Access Compliance Report

Public Rights-of-Way

(Curb Ramps)

Intersection ID: 10029993	Main Street: LANCASTER_HY	Cross Street: N/A	Location: NE
ADA ID: 2C619D240AD6	Ramp Type: Perp	Initial Pass/Fail: Fail	Overall Compliance: No
Severity Score: 13.75			
Codes/Mitigation Info/Possible Solution		Field Measurements/Component Compliance

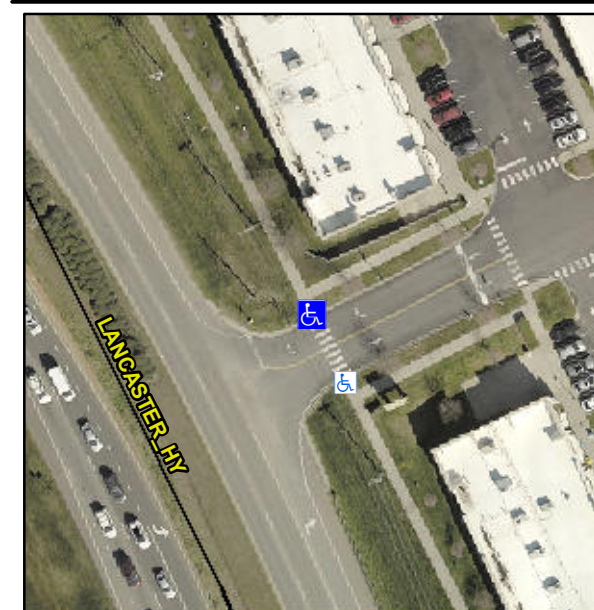
Not Found, R304.2.2, R304.5.3

Compliance	Description	Data	Compliance	Description	Data
N/A	Ramp Length (in)	93.0	No	Ramp Slope (%)	10.2
Yes	Ramp Width (in)	48.0	No	Ramp XSlope (%)	4.6
N/A	Flare Type LT	N/A	N/A	Flare Type RT	N/A
N/A	Flare Slope LT (%)	N/A	N/A	Flare Slope RT (%)	N/A
N/A	Flare Traversable LT?	N/A	N/A	Flare Traversable RT?	N/A
N/A	Landing Length (in)	N/A	N/A	DWS Provided?	N/A
N/A	Landing Width (in)	N/A	N/A	DWS Contrast?	N/A
N/A	Landing Slope (%)	N/A	N/A	DWS Length (in)	N/A
N/A	Landing X Slope (%)	N/A	N/A	DWS Full Width?	N/A
N/A	Landing Curb? (Y/N)	N/A	N/A	DWS Offset (in)	N/A
N/A	Shared Landing?	N/A			
N/A	Gutter Ponding?	N/A	N/A	Gutter Slope (%)	N/A
N/A	Gutter Lip Ht (in)	N/A	N/A	Gutter X Slope (%)	N/A
N/A	Painted X Walk1?	Yes	N/A	Painted X Walk2?	N/A
	X Walk 1 Direction	To S		X Walk 2 Direction	N/A
N/A	X Walk 1 Width (in)	97.0	N/A	X Walk 2 Width (in)	N/A
	X Walk 1 Slope (%)	1.6		X Walk 2 Slope (%)	N/A
	X Walk 1 X Slope (%)	8.6		X Walk 2 X Slope (%)	N/A

Remove & Replace Entire Ramp.
